Subject: Class 1 Permit Modification Notification, Waste Isolation Pilot Plant Hazardous Waste Facility Permit Number: NM4890139088-TSDF

- Completion of Panel 8 Mining

Class 1 Permit Modification Notification

Completion of Panel 8 Mining

Figure A2-1
Repository Horizon

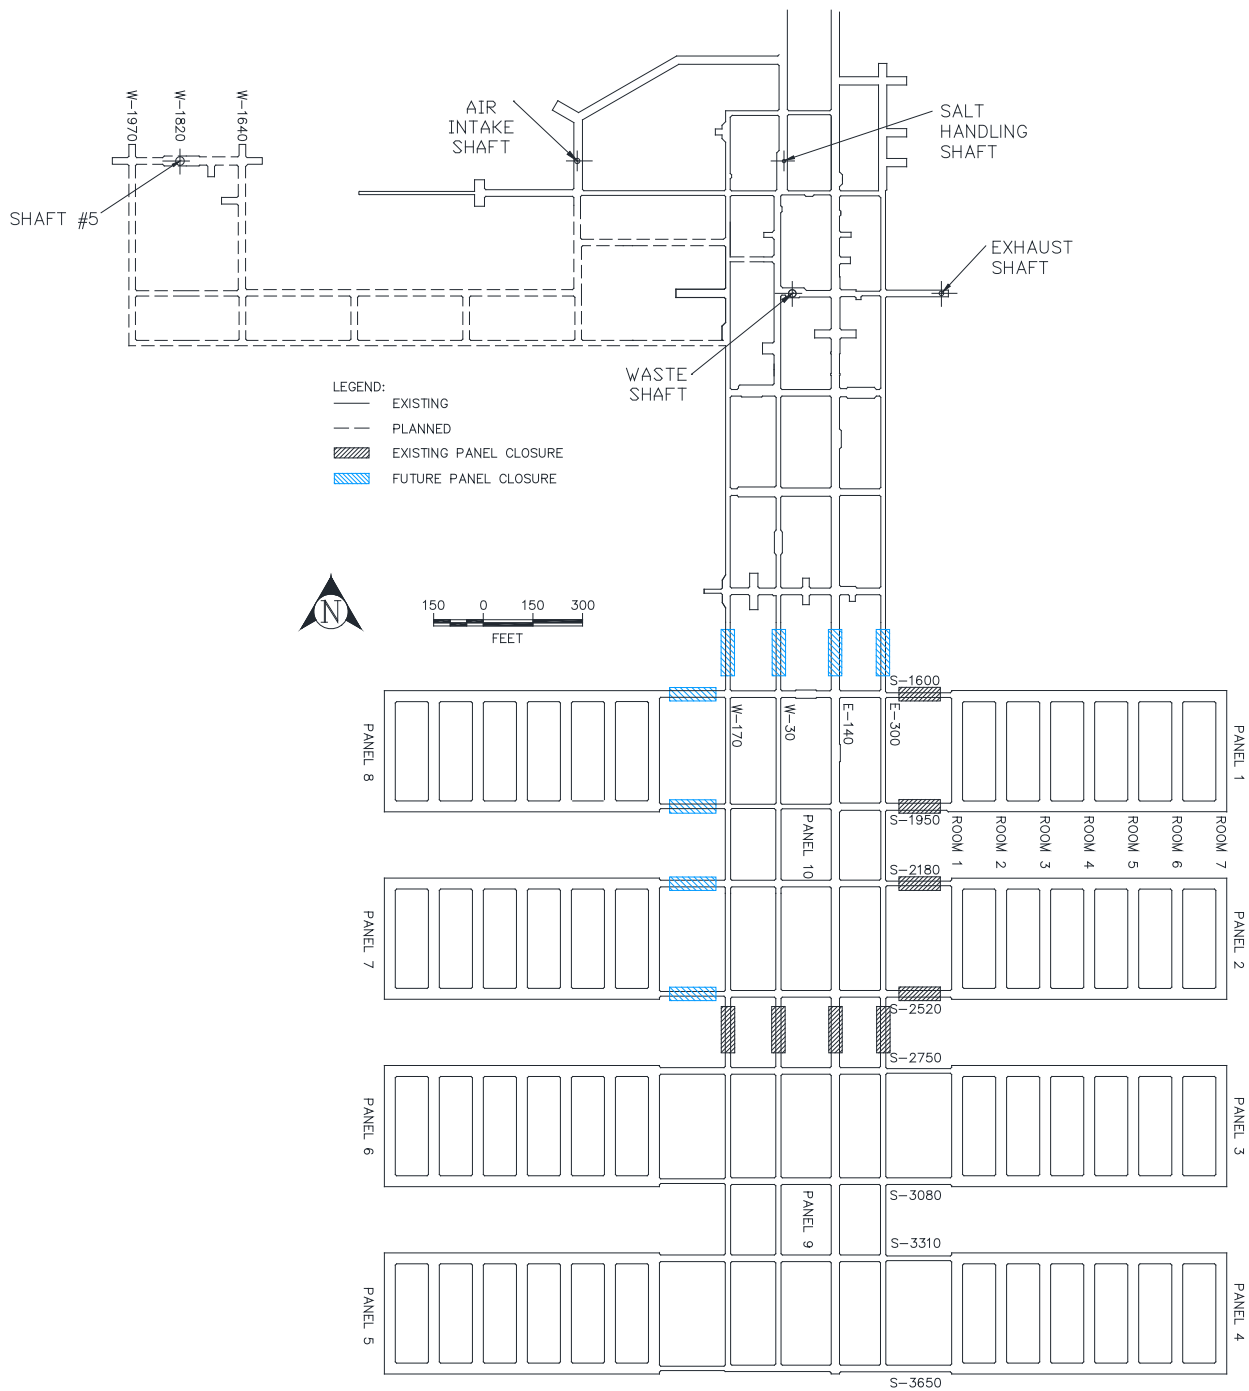
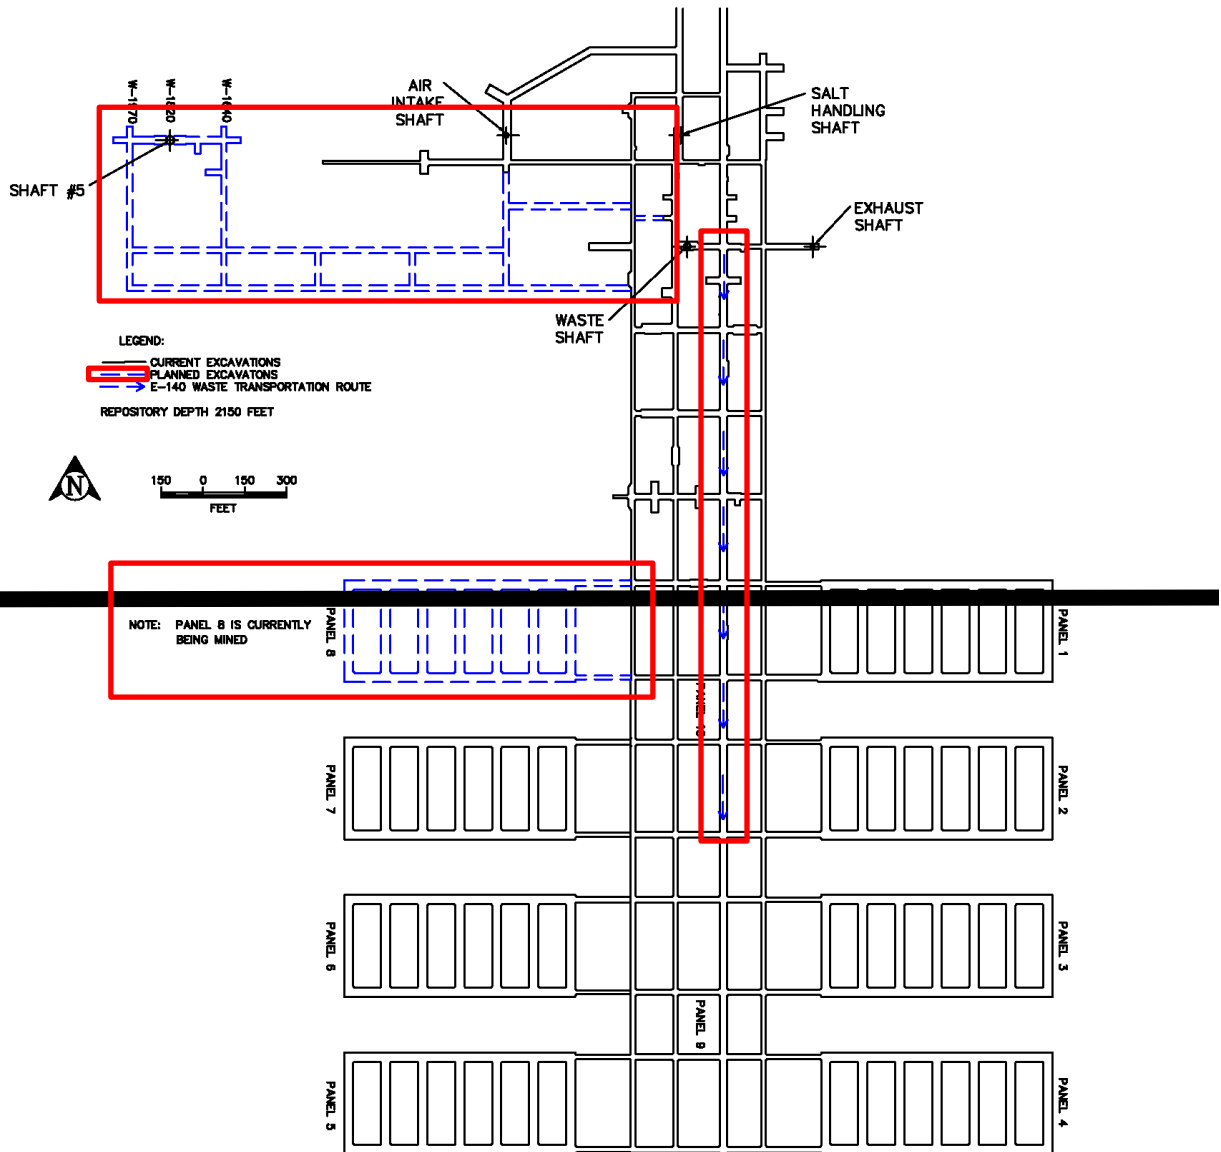
- Permit Attachment A2, Figure A2-1, *Repository Horizon*
 - Changed Panel 8 dashed lines into solid lines.
 - Deleted the following figure text: “NOTE: PANEL 8 IS CURRENTLY BEING MINED” because Panel 8 status has changed from planned to existing.

Figure A4-4
Typical Underground Transport Route Using E-140

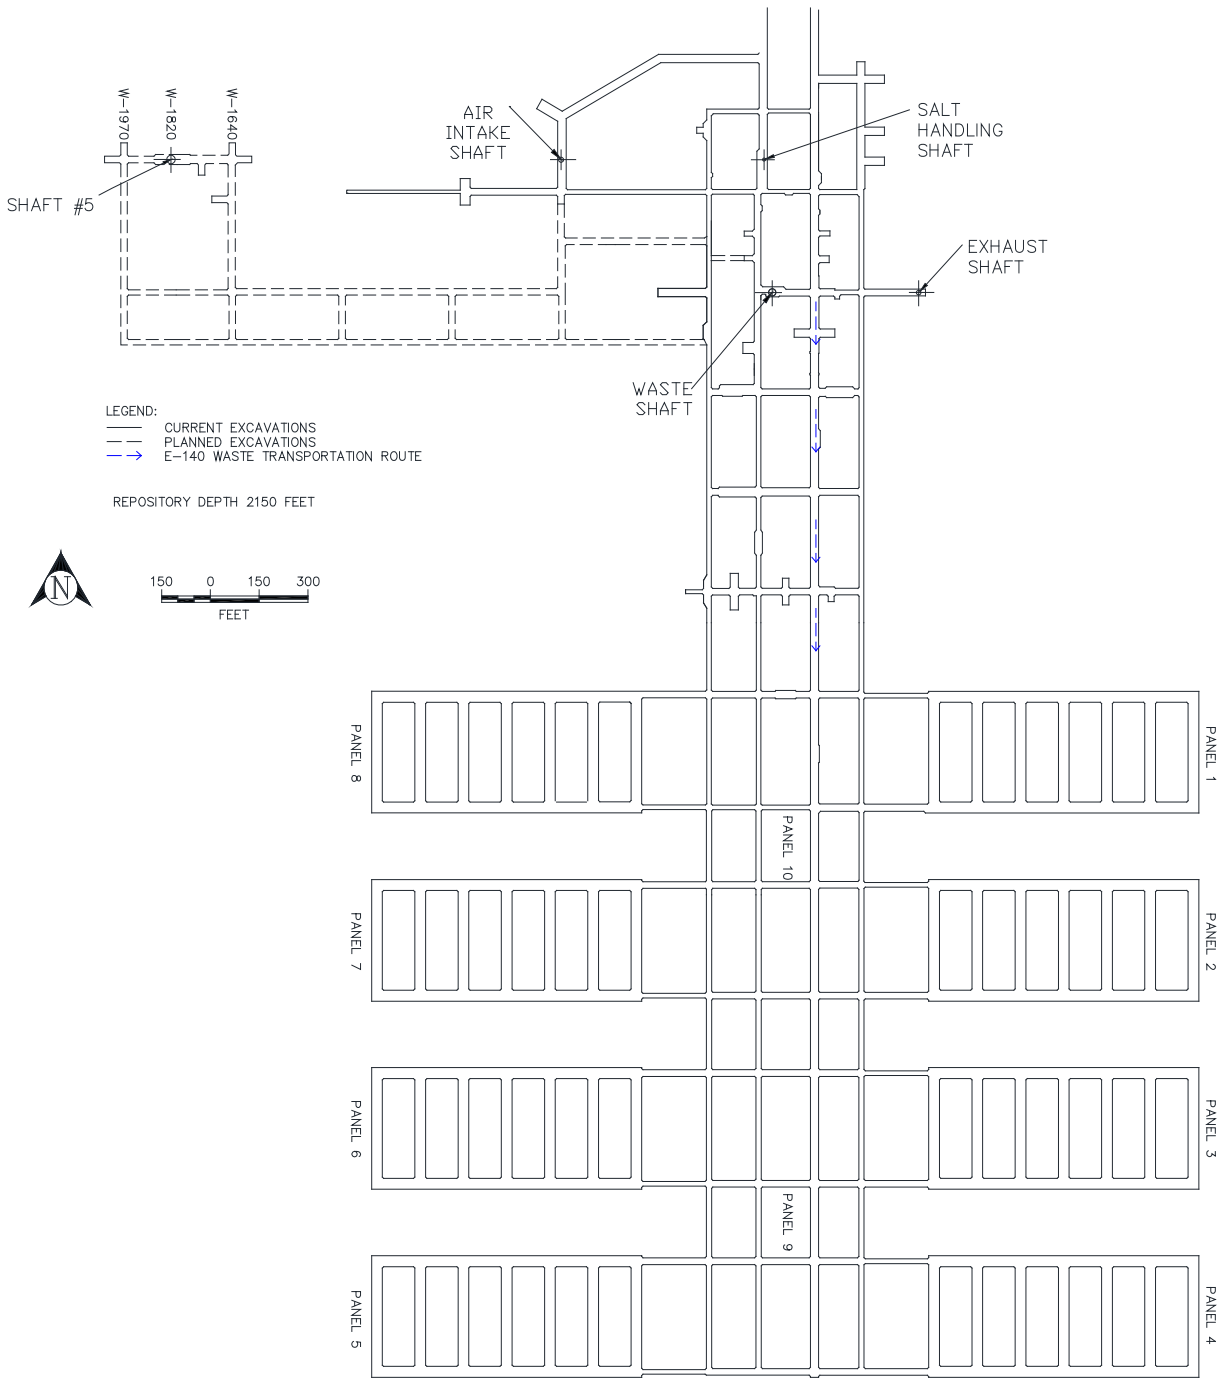
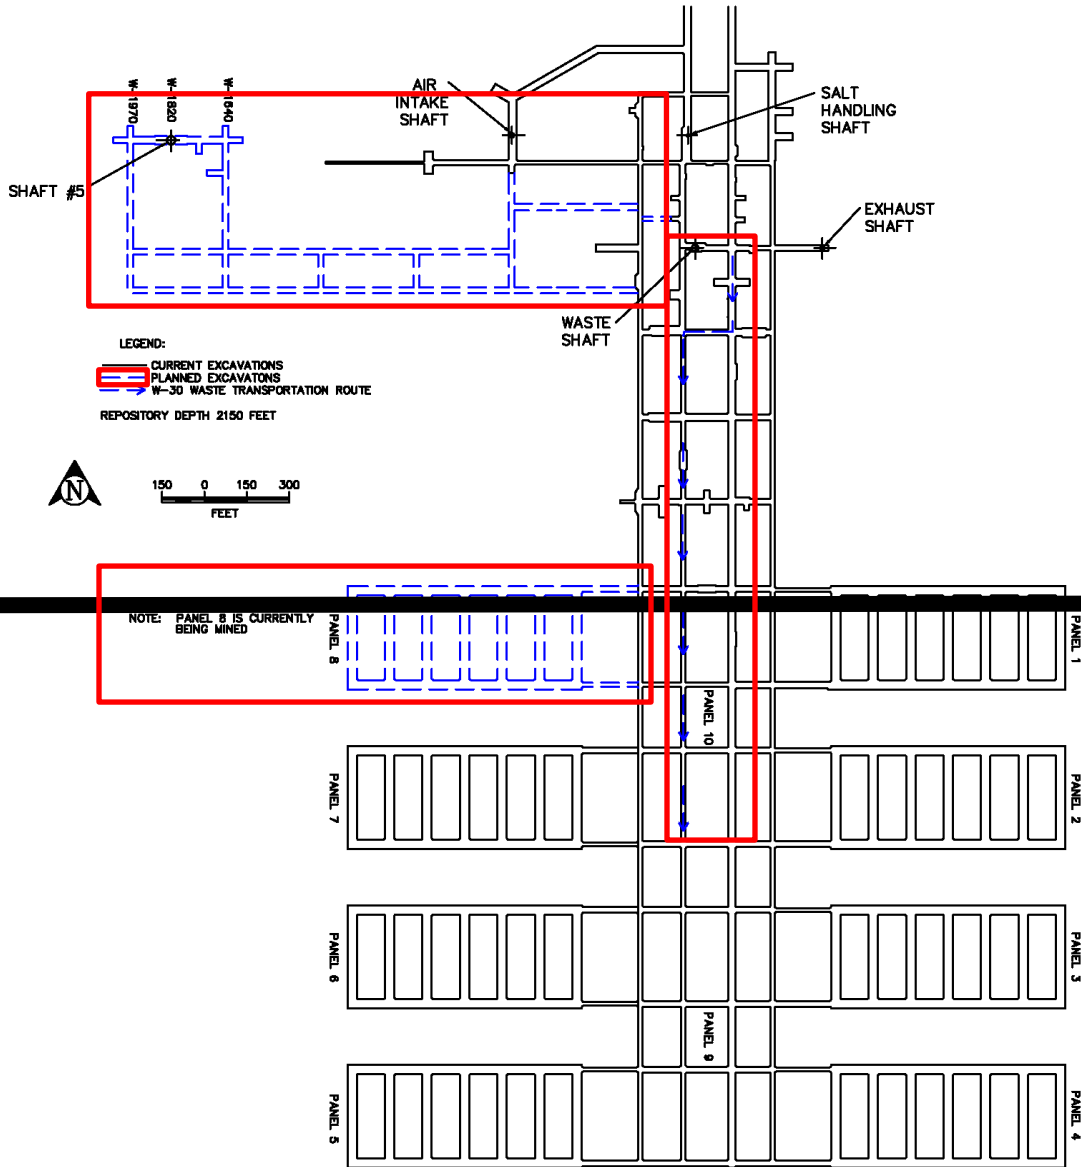
- Permit Attachment A4, Figure A4-4, *Typical Underground Transport Route Using E-140*
 - Changed Panel 8 dashed lines into solid lines.
 - Changed the planned excavations lines from blue to black.

- Changed the waste transportation route to reflect the route for waste emplacement in Panel 8.
 - Deleted the following figure text: “NOTE: PANEL 8 IS CURRENTLY BEING MINED” because Panel 8 status has changed from planned to existing.
